# Truro Board of Health

Tuesday August 15, 2023

**To:** Truro Board of Health  
**From:** Emily Beebe, Health & Conservation Agent  
**Date:** August 14, 2023  
**Re:** August 15 meeting: septic upgrades- review notes

Drawing Title:  
**SEPTIC SYSTEM SITE PLAN**  
 Sheet Number:  
**C-1**

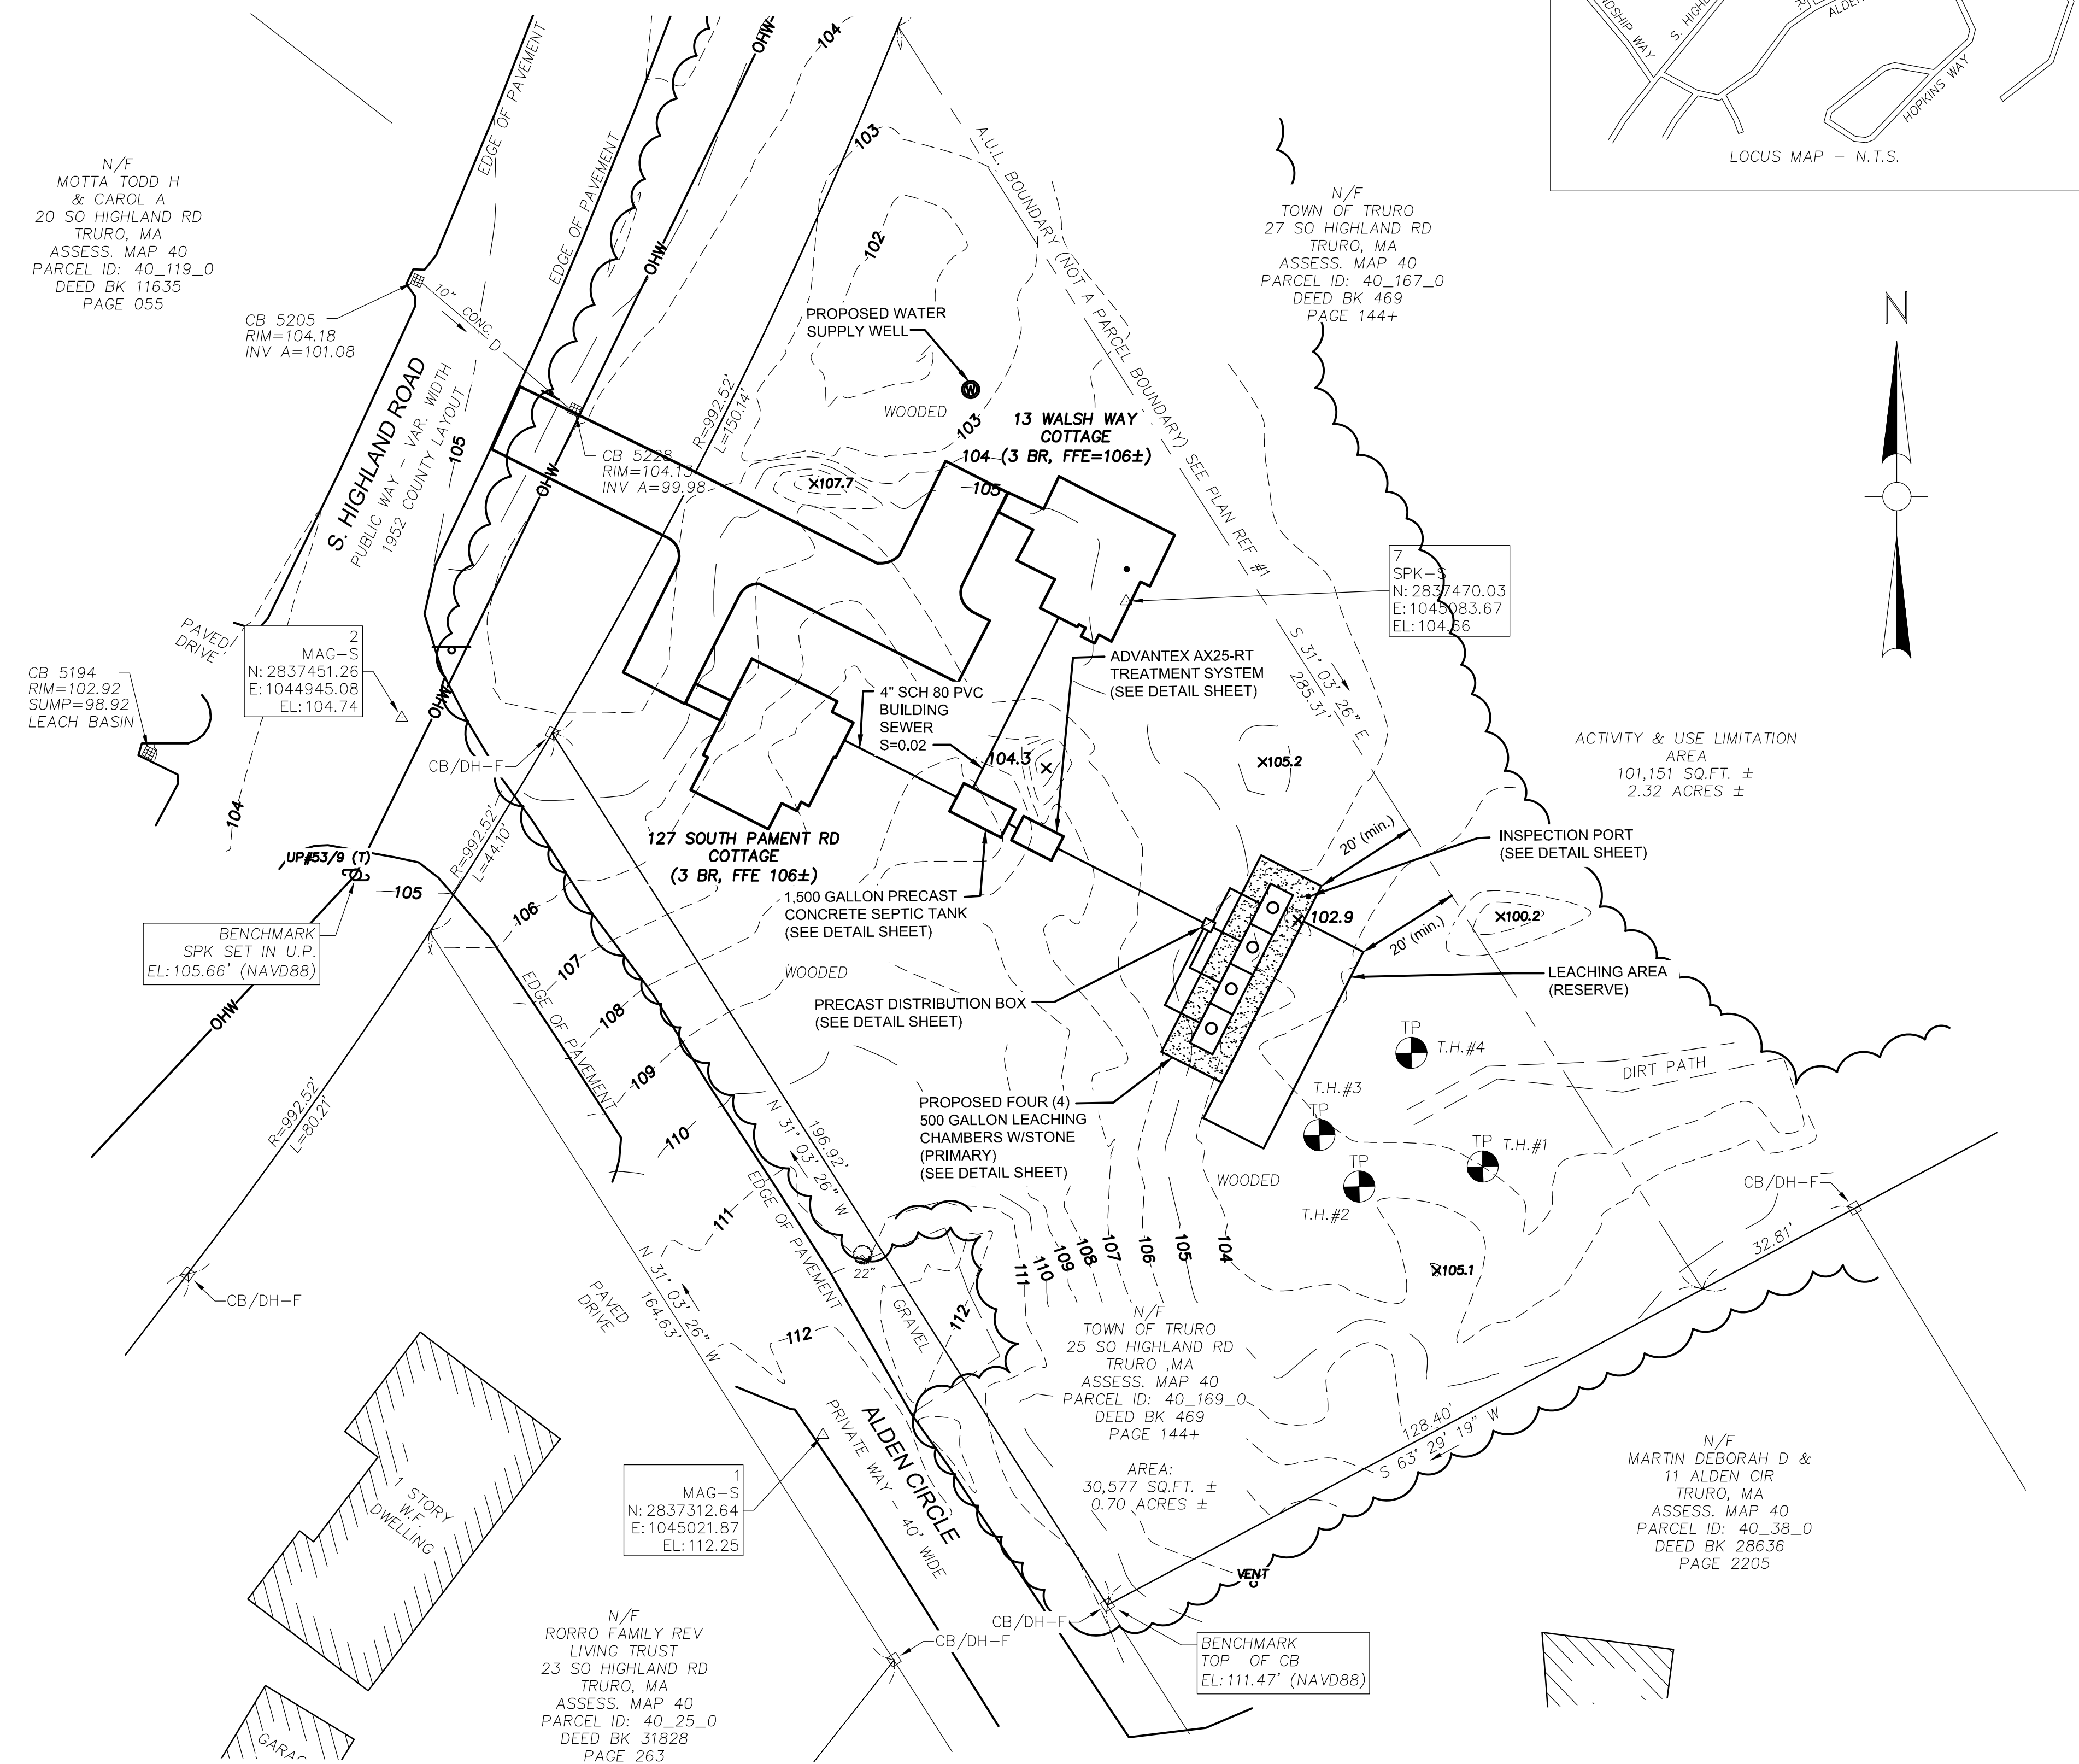
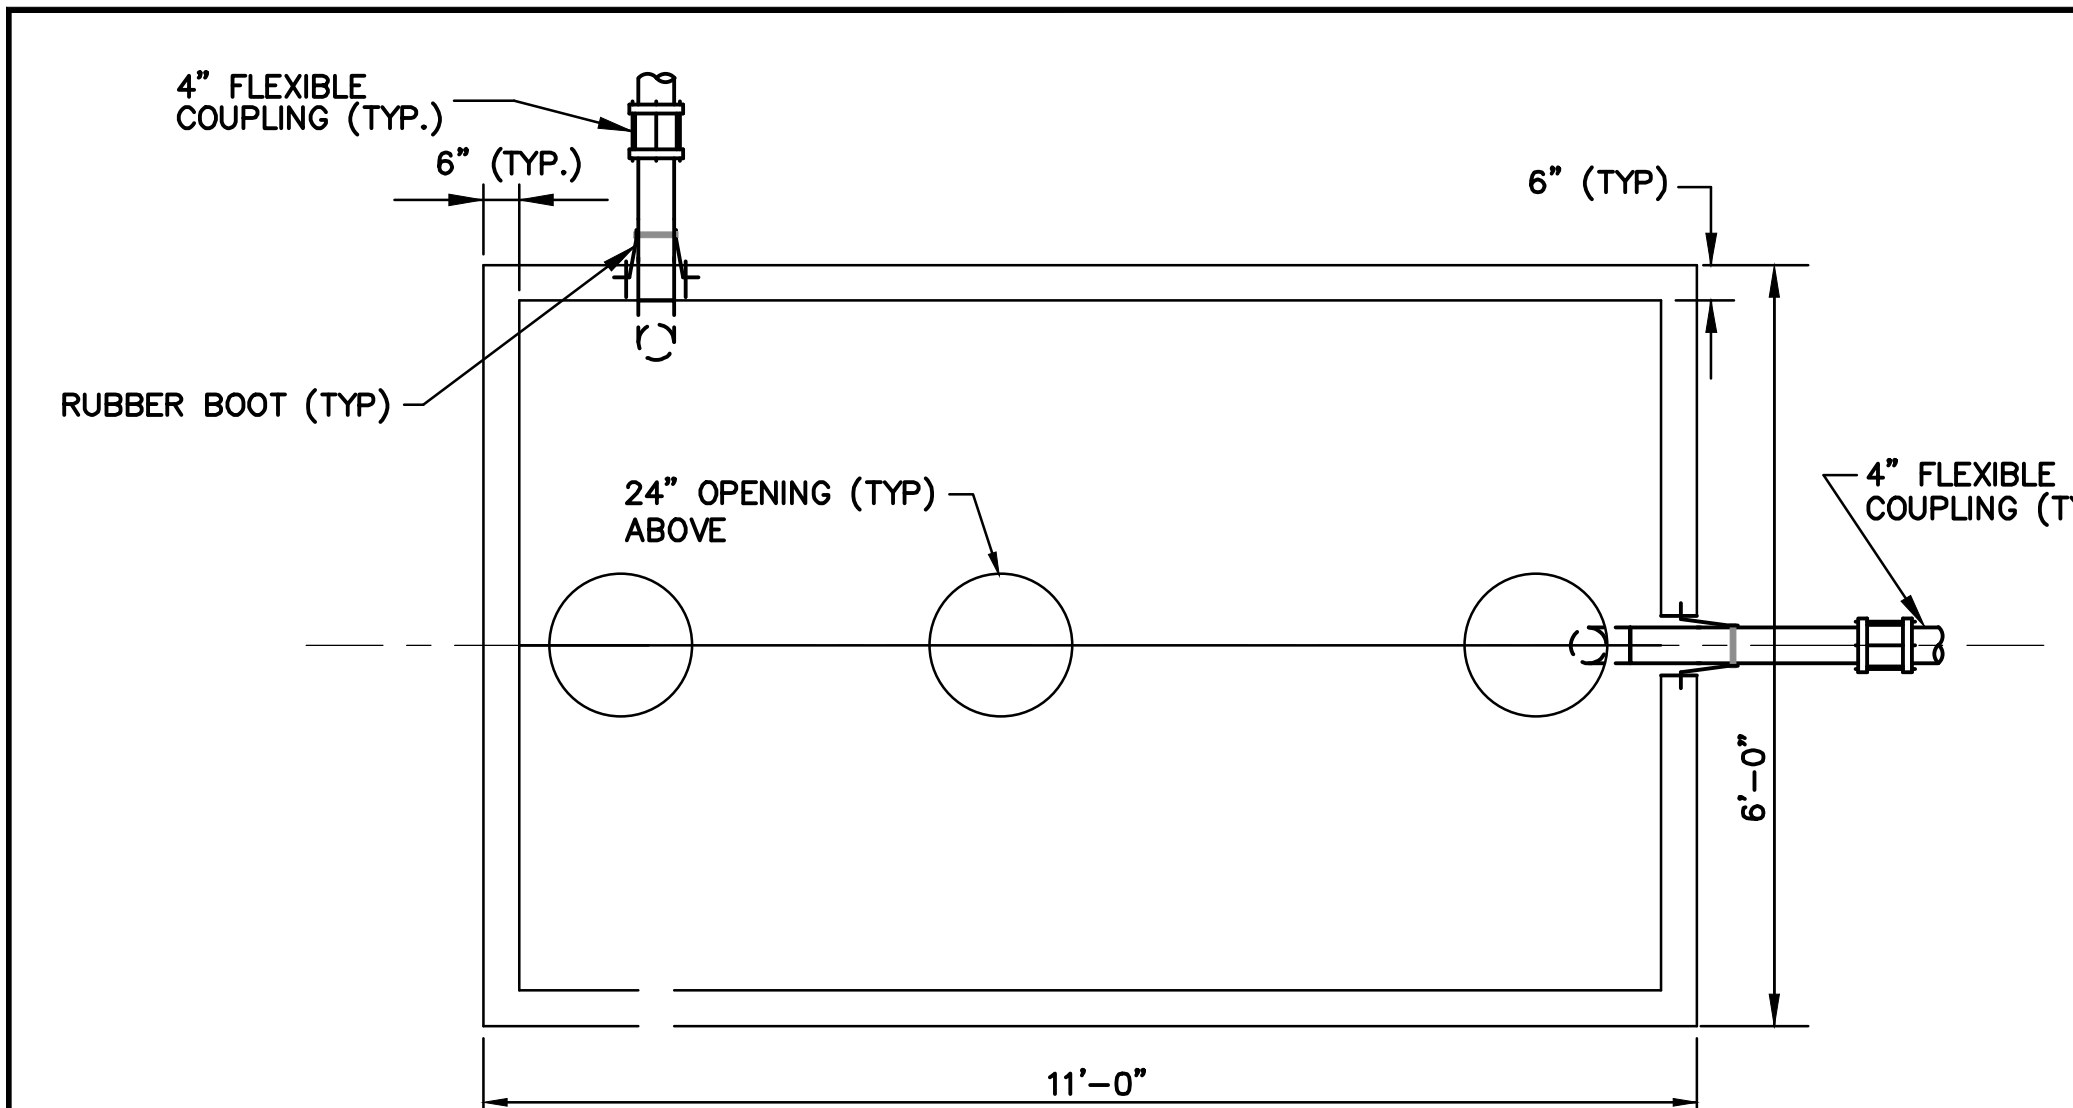
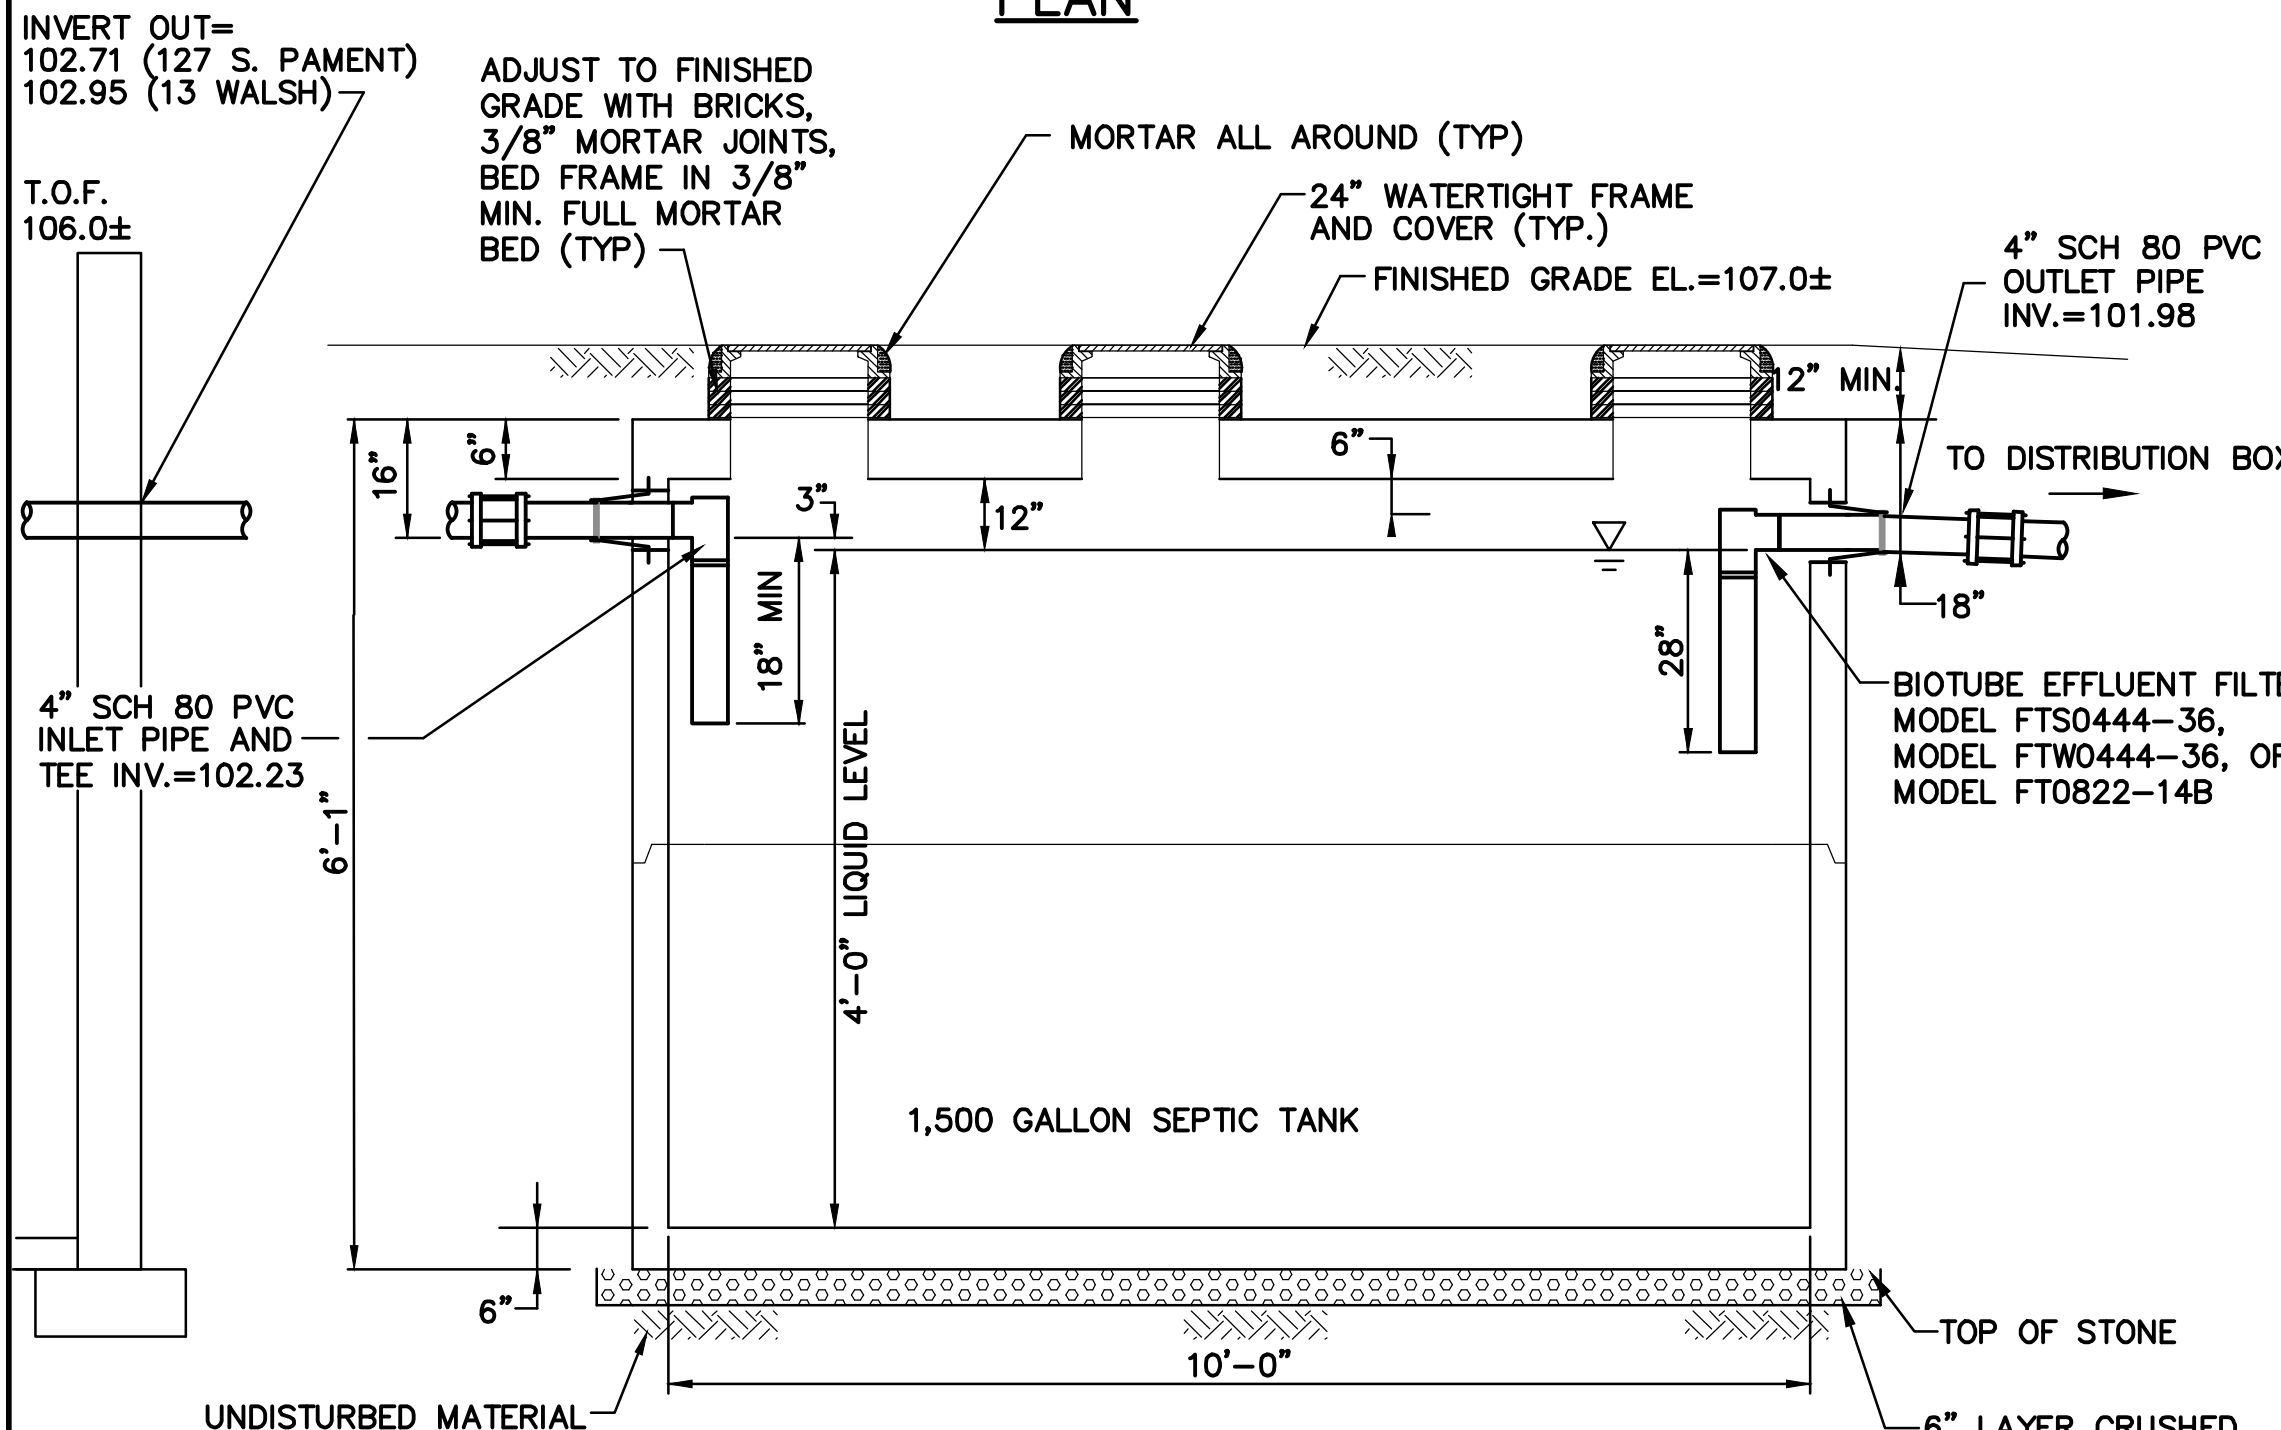
### **25 South Highland Road, Town of Truro (40/169) -Approval of Nitrogen Aggregate**

This project includes new construction of a septic system to serve 2 structures being relocated to this property. This is a  $\frac{3}{4}$ -acre parcel located in the Zone 2 of the North Unionfield well. There are no wetland resources in the vicinity. This Town-owned parcel abuts the former "burn-dump", which has been decommissioned and capped. The engineer of the project is Weston and Sampson. They have designed a 5-bedroom system that includes I/A treatment (Advantex AI-235) and seek approval to further mitigate the nitrogen load by using the available area of the abutting property in the form of Nitrogen aggregate credit land. The available (un-used) area of the abutting Town owned parcel will be designated as nitrogen credit land to meet the nitrogen loading standards of title 5.

The property has been rigorously evaluated for any environmental impacts from the abutting Town-owned parcel, (the former "burn dump") including water testing. No environmental issues have been identified.

**SITE PLAN**  
1 MILL POND ROAD  
TRURO, MA

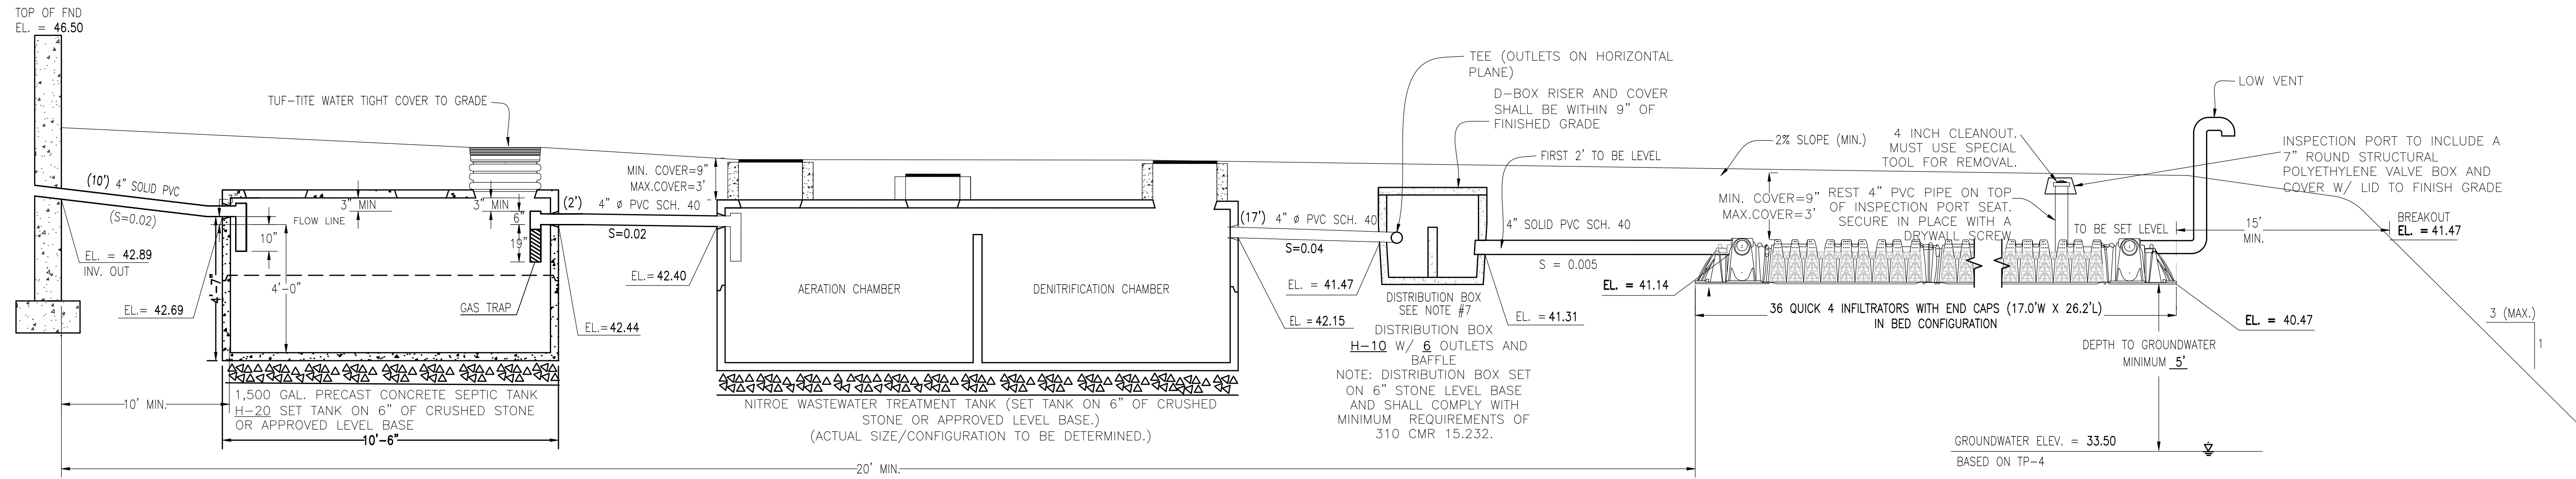
This project proposes construction of a 3-BR single-family dwelling on a 51,736 sf parcel adjacent to Mill Pond Road, Old County Road and the Pamet River. The parcel is located within the wetland resource area of Riverfront, reducing the available area of upland to approximately 21, 367 sf; this provides enough area for a 2-bedroom home under our Local Board of Health regulations.

- 150-foot separation is required between the SAS (Soil absorption system or leaching area) and the wetland resource area. 16 'is provided. This is also the case for the reserve area, which also cannot meet the required setback.
- 100' separation is required between the septic tank to Riverfront. 41' is provided.
- A variance to nitrogen loading limitations has been requested to allow construction of a 3- bedroom dwelling, rather than the 2-bedroom allowed under the regulations.

*Installation of a "Nitroe" I/A system is now proposed to mitigate these variance requests.*

The property is located in Riverfront and is within the watershed of the Pamet River. We expect that the Board will need to move to adopt a regulation to trigger upgrades to BAT\* standards within 5-7 years.

The standard of review for the Board of Health is to determine if the design showing reductions to the requirements of local regulations will provide as much environmental and public health protection as would a plan without variances. A determination (such as a statement of finding) or a motion should be made to declare whether the proposed project meets this standard of review.

1. ARTICLE 9 - SAS TO WETLANDS: A REDUCTION FROM 150 TO 16.7' FROM SAS TO THE 200' RIVERFRONT AREA (RA).
2. ARTICLE 9 - SEPTIC TANK TO WETLANDS: A REDUCTION FROM 100' TO 41.2' FROM SEPTIC TANK TO THE 200' RA.
3. ARTICLE 11 - BUILDABLE UPLAND CALCULATIONS FOR NITROGEN LOADING LIMITATIONS: A WAIVER ALLOWING THE USE OF THE OUTER RIPARIAN ZONE OF THE RIVERFRONT AREA TO BE USED IN THE BUILDABLE UPLAND AREA CALCULATIONS.
